Compte rendu de réunion / Minute of meeting

Objet / Subject: SPIRE SMEC FM Delivery Review Board

SMECm FM Pre Delivery Review

Delta DRB for the PFM SMEC.

Removal of the extruded material

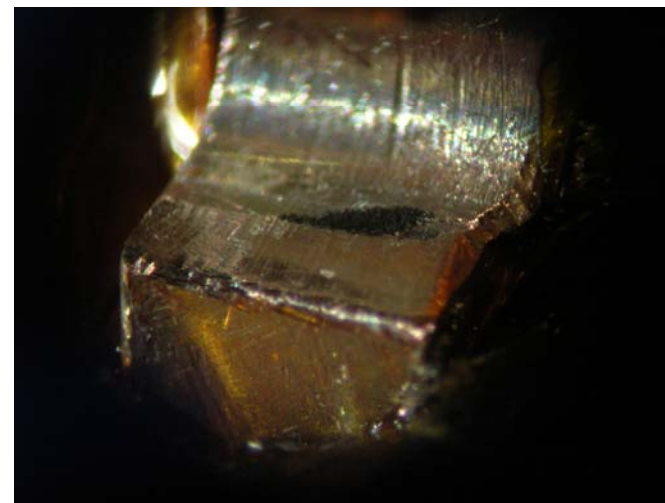
- The friction was due to the material extruded by shocks during vibrations that blocked the movement of the mechanism
- The friction has been eliminated by removing the extruded material and increasing the gaps up to the middle of the shock surface (19 May to 6 June 2006)
- Was done on all the Z and on the Y backend mechanical stops

Friction and no friction

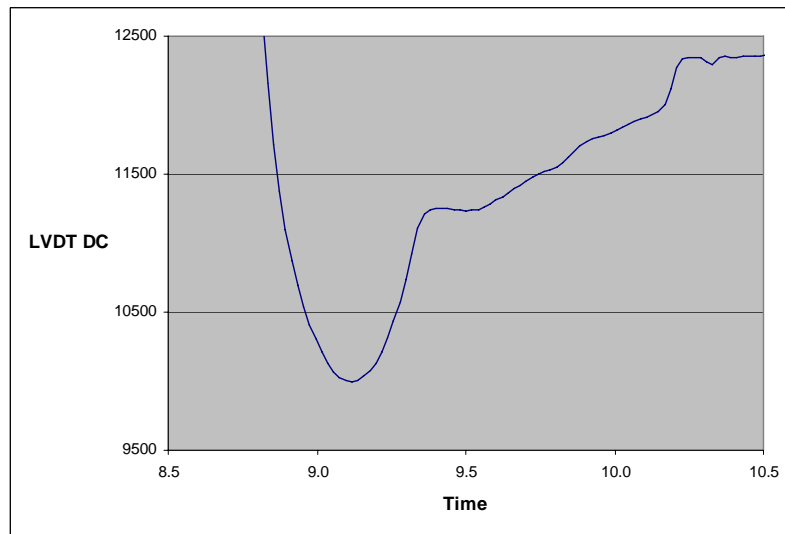
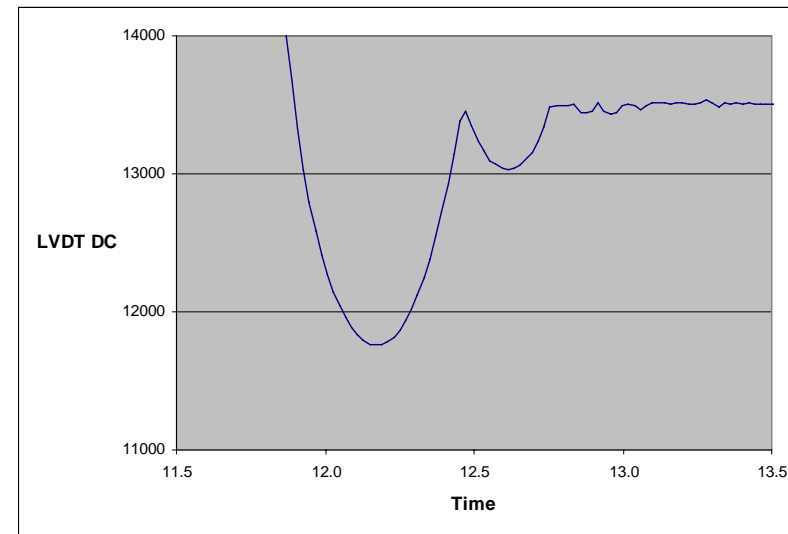
With friction

Cryo 13/05/2006

Without friction

Cryo 07/06/2006

Speed

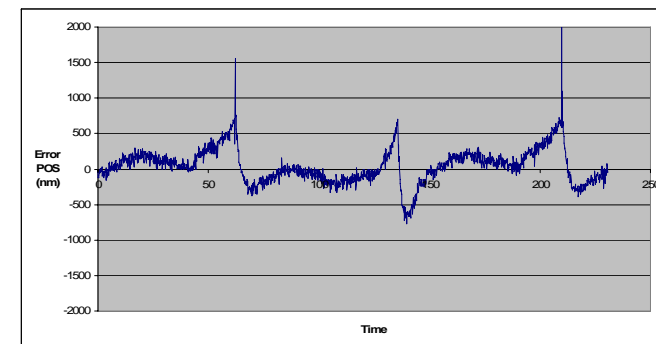
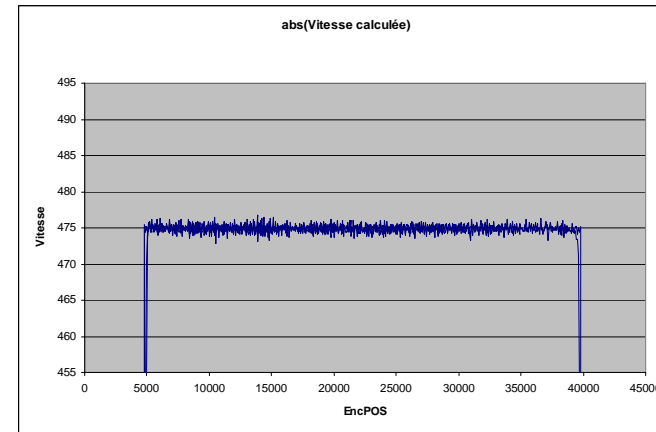
Speed = 475 μ /s when 500 μ /s
commanded

- Due to scheduler timing and software:
- The speed is calculated by the software as a function of elementary task.
- The elementary task is 21 μ s instead of 20 μ s at the beginning.

Speed stability : within 10 μ /s
R.M.S. except when changing
the direction

Optical encoder behaviour

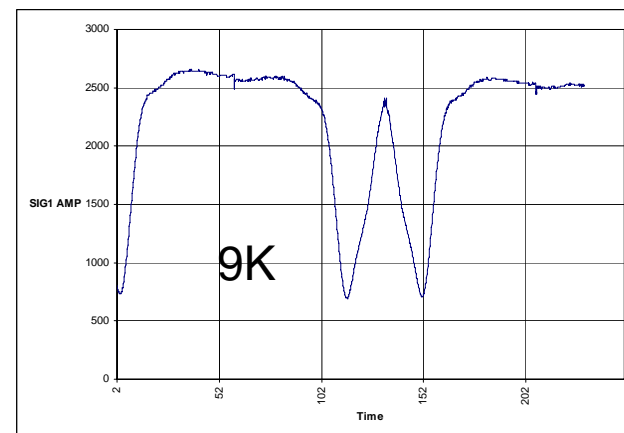
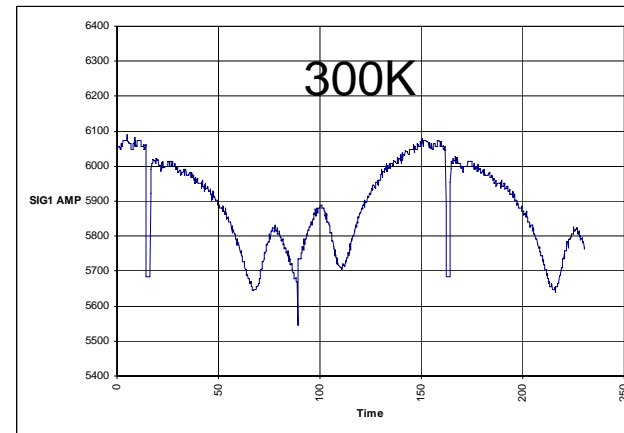
Loss of amplitude along the travel:

- 6% at 300K
- 70% at cryo temperature

Due to the rule

- Does not come from a particle
- Might be due to a scratch on the rule

Difference between 300K and cryo temperature due to a lateral relative displacement of the rule w.r.t. then head

The software copes with it.
